TECHNICAL BULLETIN

412-21-247

MODEL AFFECTED: 412EP

SUBJECT: DISPLAY UNITS (DU) P/N 412-374-009-ALL
ELECTRICAL INSTALLATION, MODIFICATION OF

FIGURE 1 – DU-1, 3160DS1P2

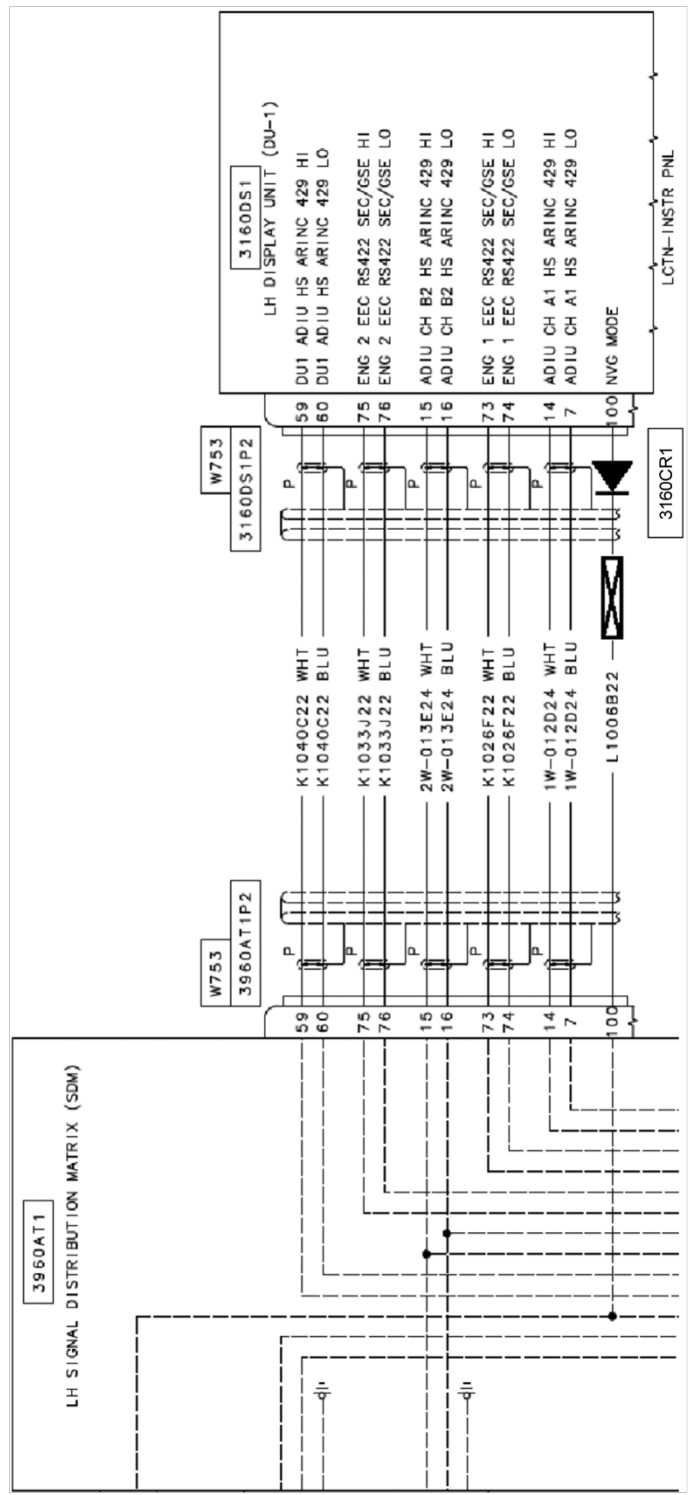
11. With a crimping tool AD-1377, splice wire L1006B22 to the lead wire on the cathode (-) side of diode assembly 3160CR1 P/N 30-251-71AA. Refer to the wiring diagram in Figure 1.

12. Place the ident tubing (Figure 1), identified with 3160CR1, on the diode assembly and apply heat until the tubing shrinks in place.
13. Insert the respective lead wire of diode assembly 3160CR1 into pin 100 of the connector 3160DS1P2. Refer to the wiring diagram in Figure 1.

FIGURE 2 – DU-2, 3160DS2P2

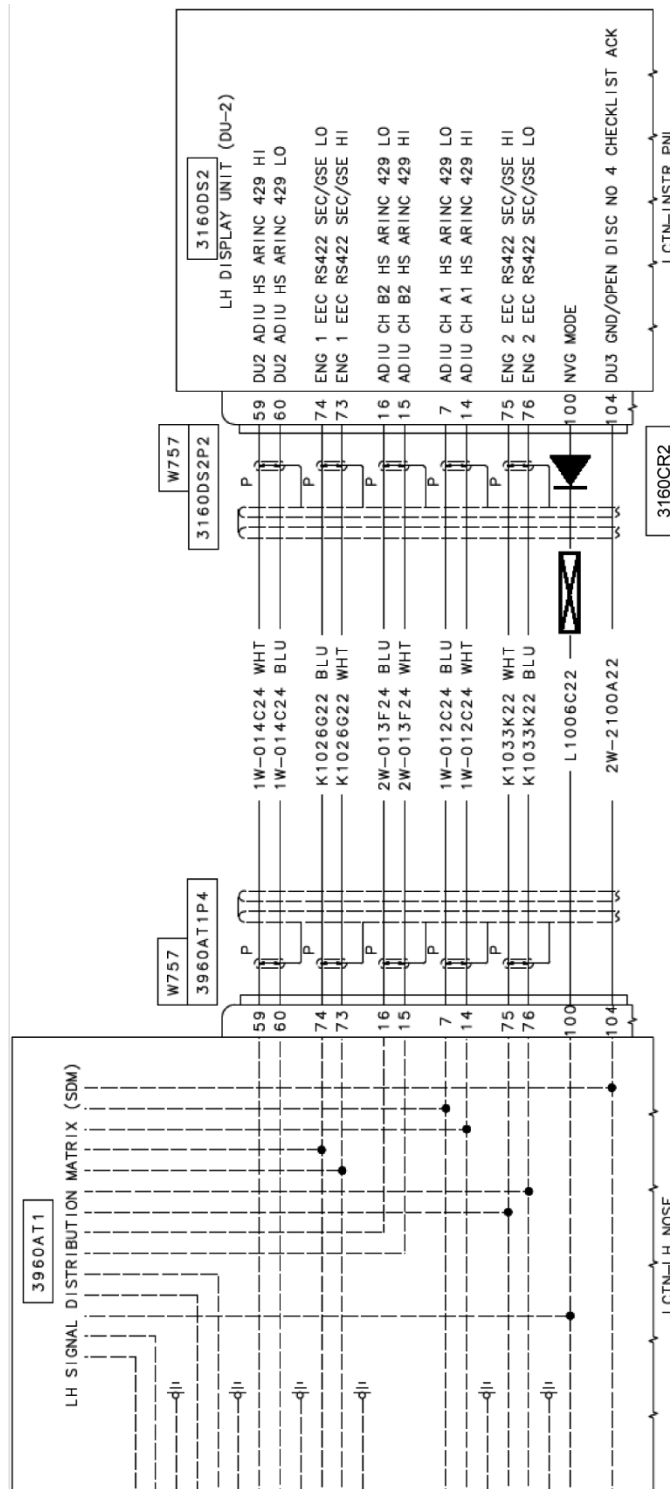
16. Repeat step 4 to step 15 for wire L1006C22 for the copilot DU connector 3160DS2P2 using diode assembly 3160CR2 P/N 30-251-71AA and ident tubing identified with 3160CR2. Refer to the wiring diagram in Figure 2.

FIGURE 3 – DU-3, 3160DS3P2

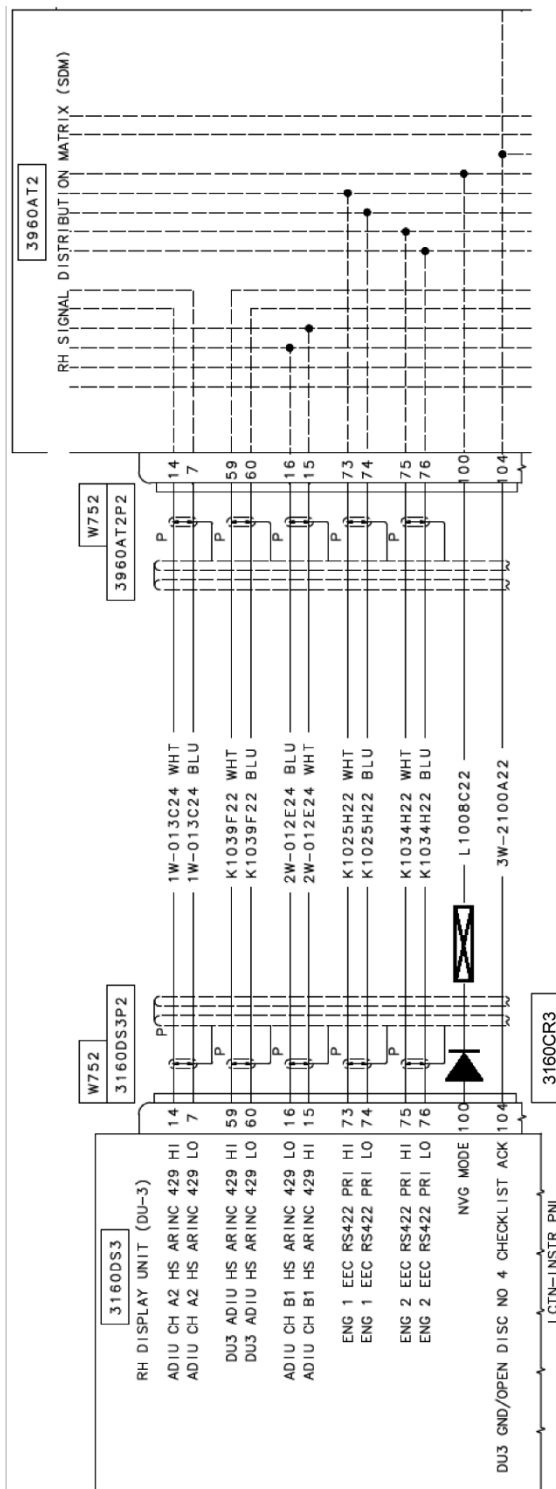
17. Repeat step 4 to step 15 for wire L1008C22 for the pilot DU connector 3160DS3P2 using diode assembly 3160CR3 P/N 30-251-71AA and ident tubing identified with 3160CR3. Refer to the wiring diagram in Figure 3.

FIGURE 4 – DU-4, 3160DS4P2

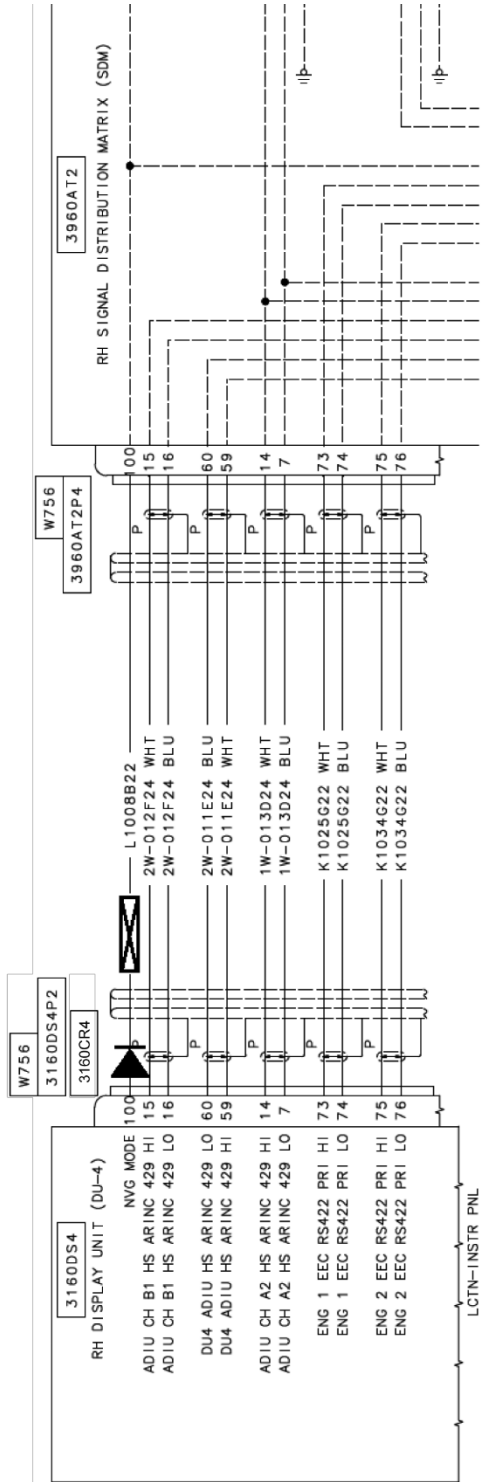
18. Repeat step 4 to step 15 for wire L1008B22 for the pilot DU connector 3160DS4P2 using diode assembly 3160CR4 P/N 30-251-71AA and ident tubing identified with 3160CR4. Refer to the wiring diagram in Figure 4.

FIGURE 5 – 8TB1-K

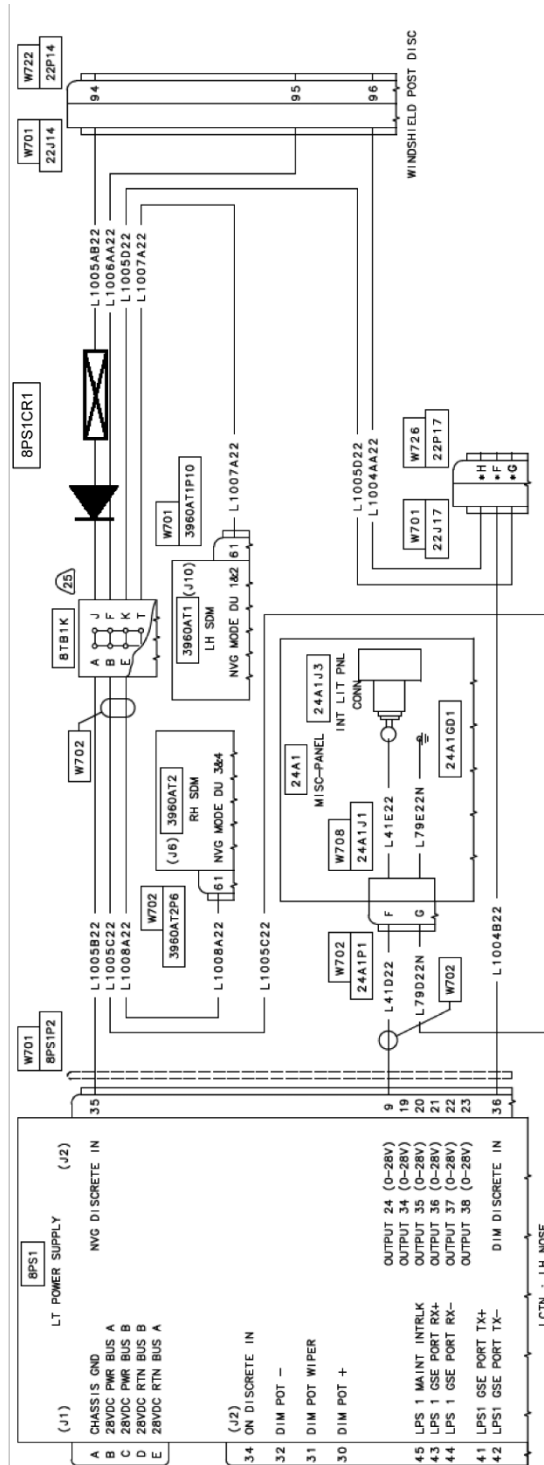
20. With a cutter remove the contact P/N M33029/22-191 from wire L1005AB22.
21. With a crimping tool AD-1377, splice wire L1005AB22 to the lead wire on the anode side (+) of diode assembly 8PS1CR1 P/N 30-251-48AA. Refer to the wiring diagram in Figure 5.

22. Place the ident tubing (Figure 5), identified with 8PS1CR1, on the diode assembly and apply heat until the tubing shrinks in place.
23. Insert the respective lead wire of diode assembly 8PS1CR1 into pin J of terminal block 8TB1-K. Refer to the wiring diagram in Figure 5.
